**RE: CONTRACT NO. CPA/219532 – WALLARAH 2 COAL PROJECT EIS REVIEW  
– GROUNDWATER, SURFACE WATER, FLOODING AND SUBSIDENCE  
IMPACTS**

## **CONTRACT NO. CPA/219532 – WALLARAH 2 COAL PROJECT EIS REVIEW**

**GROUNDWATER, SURFACE WATER, FLOODING AND SUBSIDENCE  
IMPACTS**

**PSM2015-004R     June 2013**

**Figure 17:** Computed mine inflows as given in the EIS

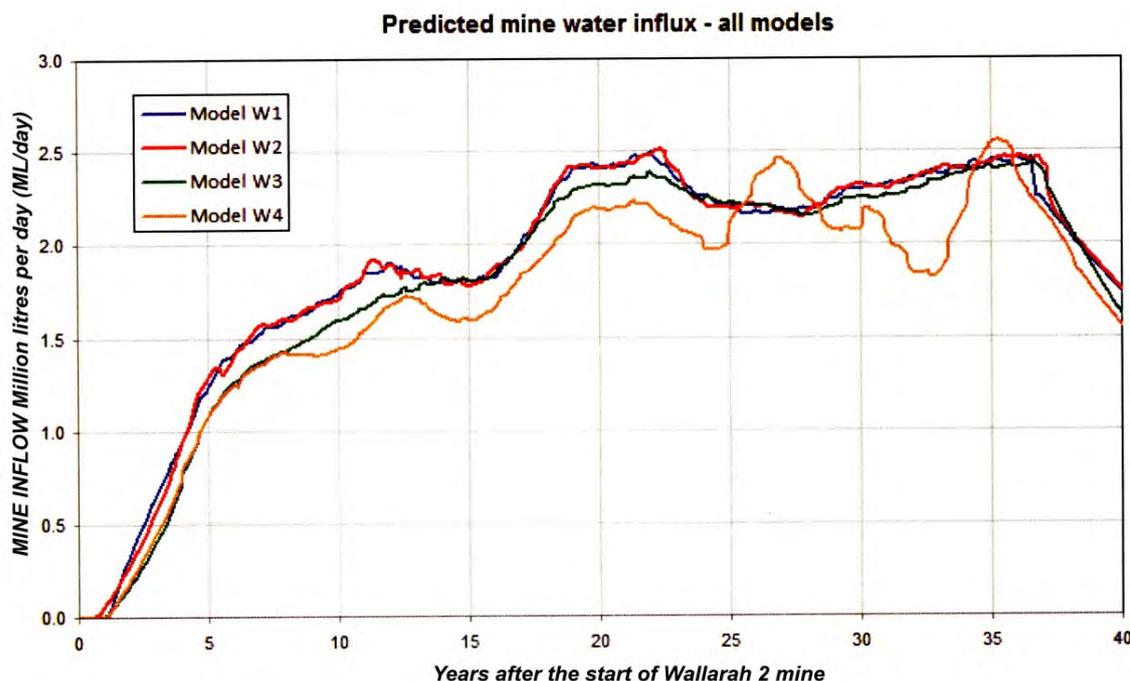
It can be seen that computed inflows reach about 1.5ML/day in Year 6 and are up to 2.5ML/day for 15 to 20 years after about Year 18. The EIS also notes that these calculations do not include flows from fracture zones which are estimated to potentially increase inflows by about 0.5ML/day.

The EIS does not provide any attempt to reconcile where this water comes from. It implies that it would largely come from water stored in the ground, but this avoids the fact that water stored in the ground comes from somewhere, and is in equilibrium with natural recharge. A valid way to consider this matter is encapsulated in the following quotation from Dr Rick Evans, principal hydrogeologist of Sinclair Knight Merz, viz:

**Figure 18:** Pre-mining groundwater regime from Figure E17 of Appendix H of the EIS

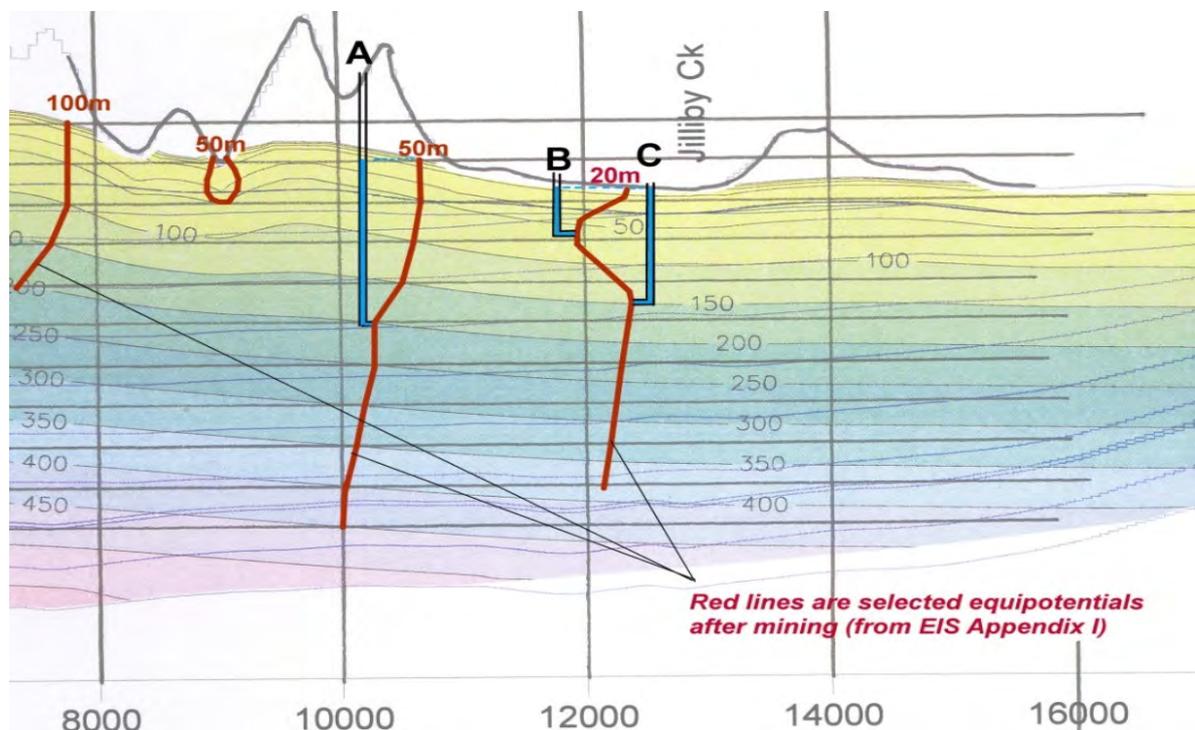
Figure E17 of Appendix H of the EIS gives calculations of the groundwater pressure regime around the mine under natural conditions, at the end of mining (Year 38). In this form the plots do not provide guidance on near surface flow lines that illustrate the flow path. The discussion and figures below set out to present the data from the EIS in a practical form to illustrate the impact of creating a groundwater sink in the form of the underground mine.

Figure 18 is an annotated version of part of the EIS plot of natural groundwater conditions above the mining area. To interpret the plot 'equipotential lines' have been annotated onto the EIS data. Equipotential lines indicate the level the water in a well will rise to which on the Figures below is benchmarked against the height above sea level (AHD). So in the case below the equipotential lines show the level water would rise to in a well open only at the bottom, whose bottom is placed on that equipotential line.

Three imaginary wells have also been annotated onto the two figures below, Wells A, B and C. These have been selected to illustrate the results of the MER modelling on the level of water that would appear in a very deep, a mid-range and a shallow bores in the Dooralong Valley.

The water level in the well is shown by the blue column for each well. It can be seen that the two wells (B and C) on the 20m equipotential line rise to the same level, namely RL20 m.

**Figure 19:** Prediction in the EIS of the groundwater regime at completion of mining

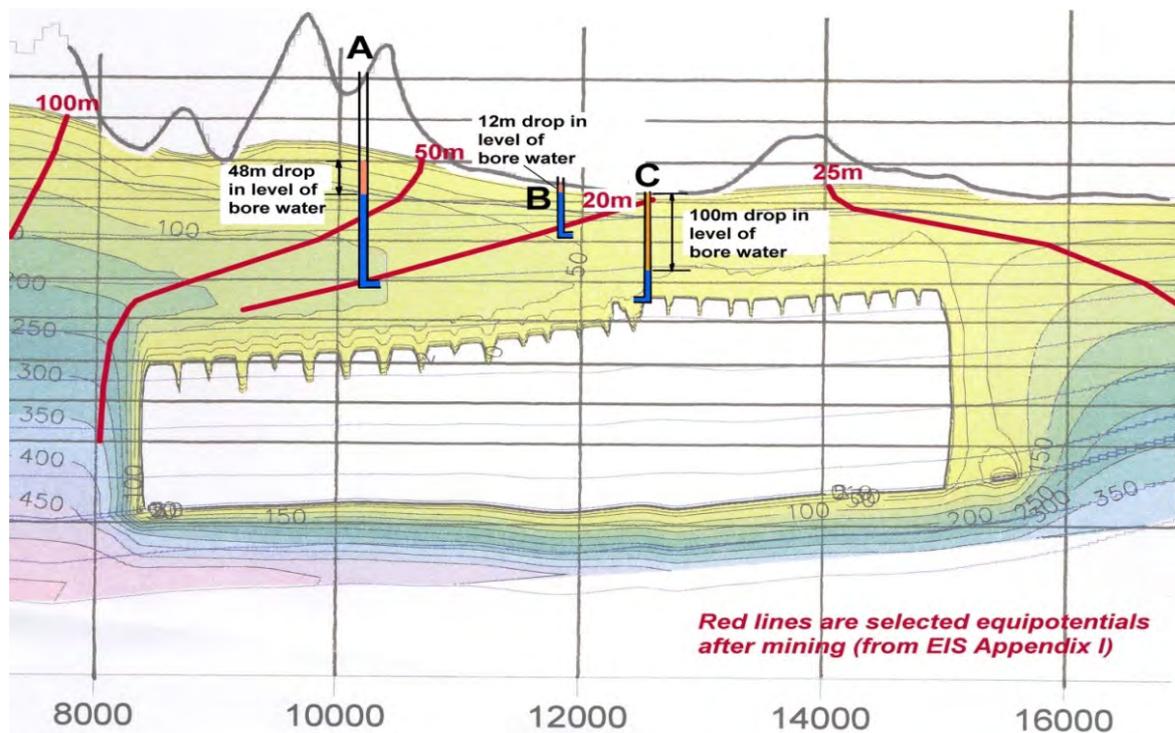
Figure 19 is the prediction in the EIS of the groundwater regime at completion of mining. Again, selected equipotential lines and the three imaginary wells are annotated onto the figure. The water levels in these wells predicted at the end of mining are again shown by the blue columns. The drop in level for each well is shown by the orange column and as written on the figure. It can be seen that:

- the water level in Well A drops 48m;
- the water level in Well C drops 100m; and
- the water level in the mid-range, 70m deep, Well B drops 12m.

Water level drops in the wells annotated above are substantial and indicate significant changes to the groundwater regime. These pressure drops within the rock must reflect in pressure decreases within the shallow alluvium within the Dooralong Valley, and these decreases, in turn, cause the decrease in base flows to Jilliby Jilliby Creek that are discussed earlier.

**Figure 20** Vertical Permeability values from Appendix F of the EIS versus values used in groundwater impact assessment in Appendix G (After Figure 2.35 Valley Case)

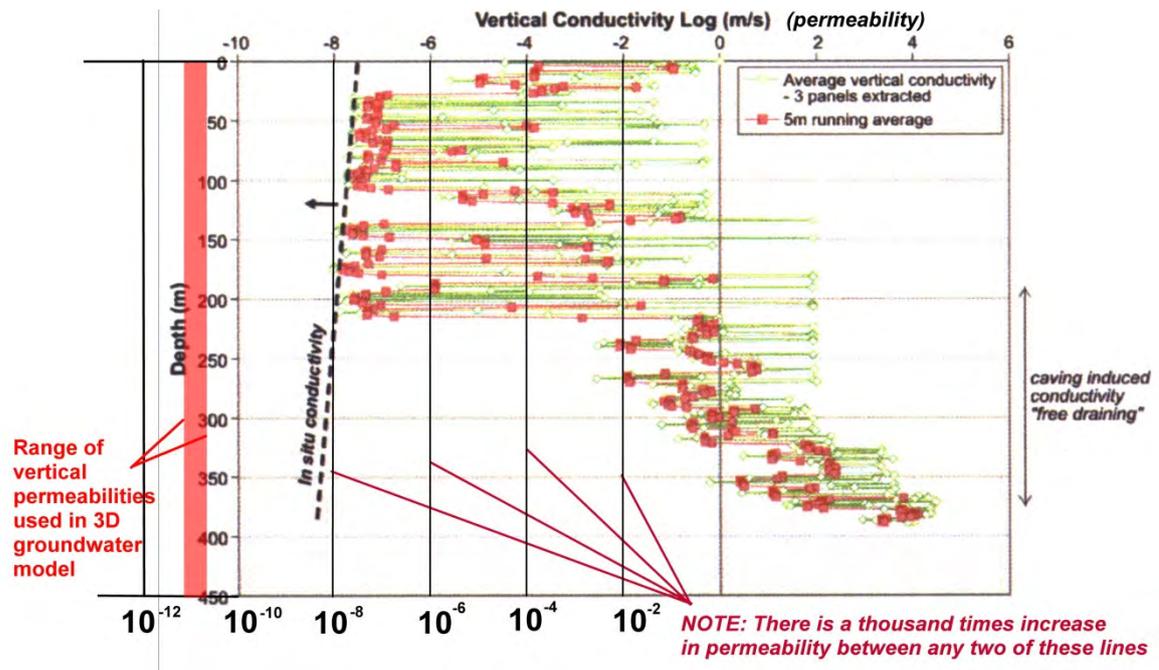
To demonstrate the large differences between what the EIS states as being appropriate permeability ranges, and what has actually been used in the EIS to assess impacts on the groundwater regime, we have plotted, in Figure 20, the parameters used by MER (3D model) against the 'valley' case permeability ranges given in Appendix F.

Figure 20 indicates that the hydraulic conductivity values adopted in the MER W2CP model are substantially on the low side of any realistic range of possibilities which have been identified within the EIS itself. If the values provided in Figure 20 were adopted the computed mine inflows, and the rate at which depressurisation progresses through the strata would be substantially higher.

**Figure 21** Distribution of synthetically generated permeability values in the constrained zone by MER – Figure 27a in Appendix H of the EIS

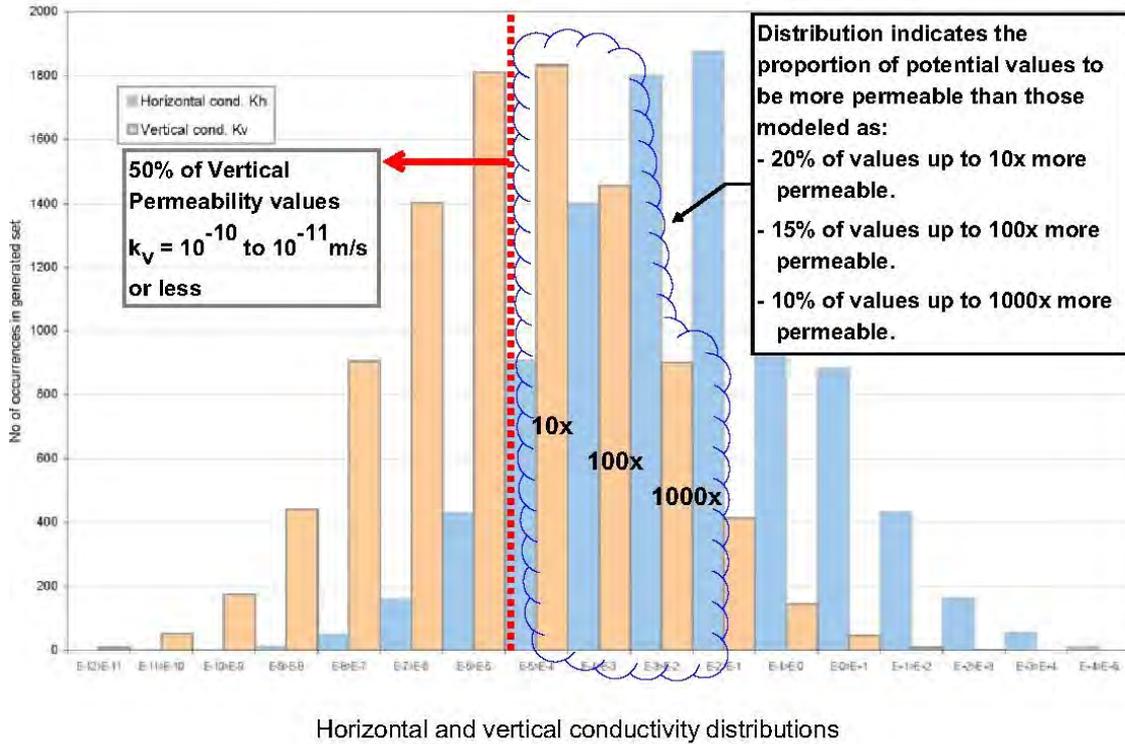
Indirectly MER appear to agree with this assessment. Figure E27a from Appendix I repeated below as Figure 21, shows a distribution plot of vertical ( $k_v$ ) and horizontal ( $k_h$ ) conductivity for the Constrained Zone from a synthetically generated randomised distribution.

Interpretation of the data presented in Figure 21 shows that at about 50% of the realisations of vertical permeability have a value equal to, or less permeable than those modelled by MER (about  $10^{-11}$  m/sec or  $10^{-6}$  m/day). However, this indicates that 50% of the potential realisations of permeability are more permeable than those modelled. While it must be acknowledged that the plot below is a probabilistic one, it does show another view that permeability could be higher. The order of increased permeability values shown are:

- 20% of values have a value of  $k_v$  up to 10 times greater than those modelled
- 15% of values have a value of  $k_v$  up to 100 times greater than those modelled
- 10% of values have a value of  $k_v$  up to 1000 times greater than those modelled

**Figure 22** Depressurisation curves extracted from the plots of the MER W2CP model given in Appendix G of the EIS

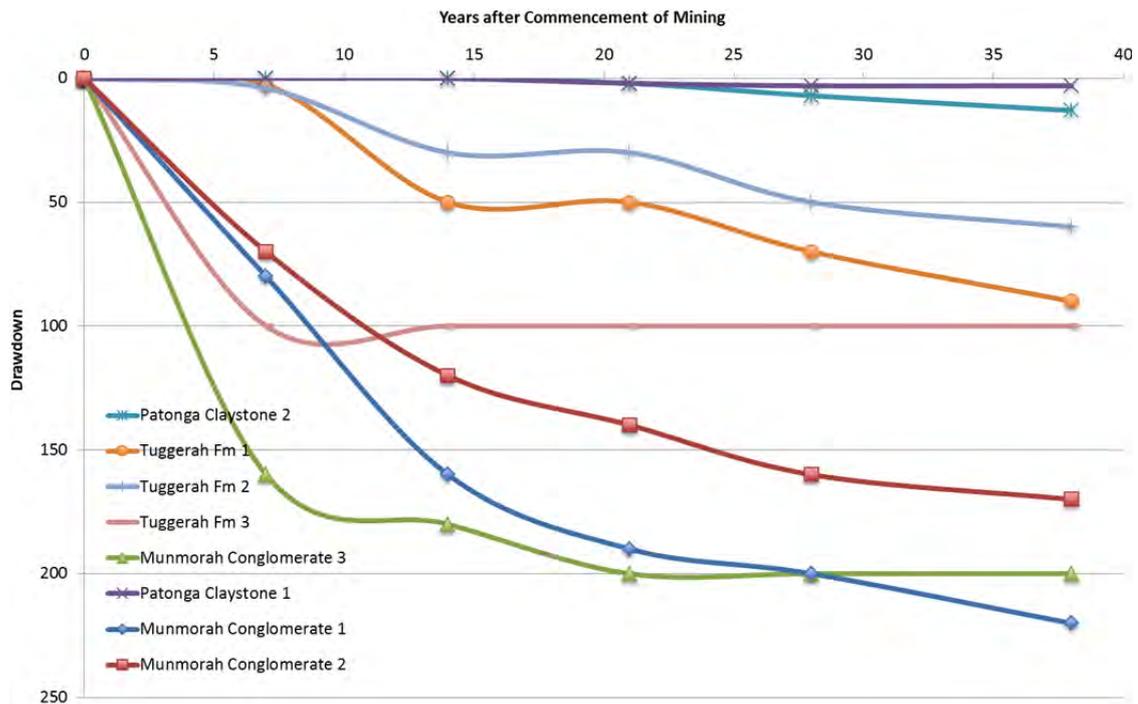
Figure 22 summarises the progression of depressurisation through the strata from the MER model, a process still continuing after 38 years. If MER had adopted the parameters recommended in the previous chapter in same EIS then depressurisation would have been calculated as occurring much faster and to a much greater extent.

Therefore, the flow quantities and extents of depressurisation discussed in Section 8.2, above, must be viewed in the context that they are non-conservative in respect to impacts on groundwater and surface waters. Therefore, the significant impacts actually shown by the MER model, as outlined in Section 8.2, could readily be more adverse, and at the very least warrant assessment with regard to sensitivity and risk.

Figure 25: Main Areas of Increased 1% AEP Flooding – Dooralong Valley

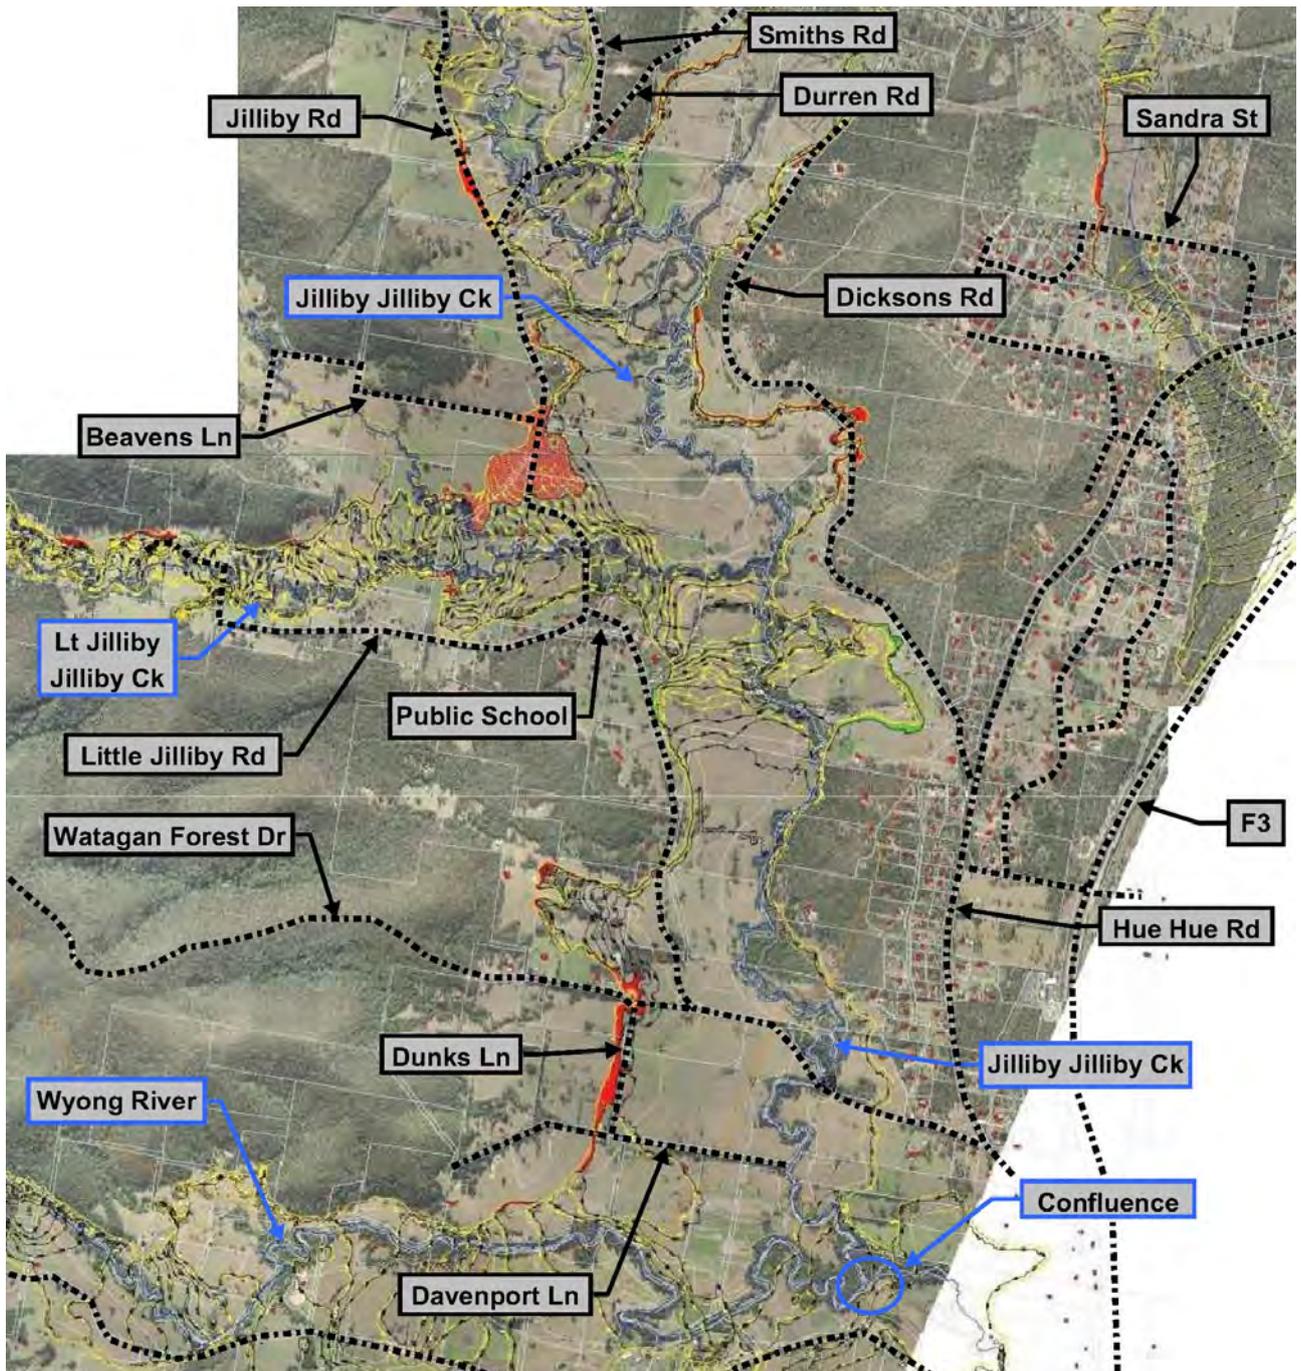
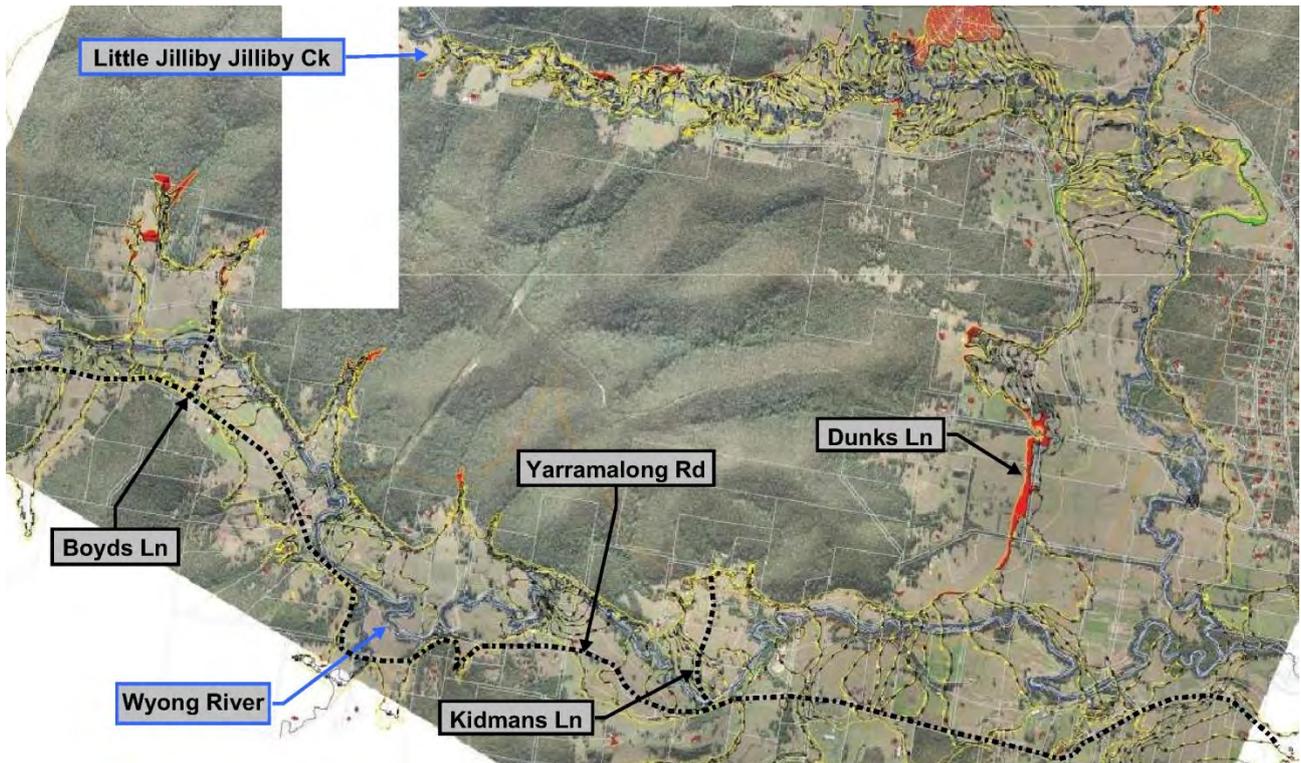
A minor, but significant point from the aspect of EIS review is that of presentation. It is difficult to interpret with any confidence what the flood levels are on the 1%AEP flood maps included in Annex I to Appendix K nor from the various Figures throughout the text of the EIS. Indeed, the only clearly defined data is that presented in Tables 6.1 to 6.5 of Appendix K with the limitation as to no actual identification of dwelling.
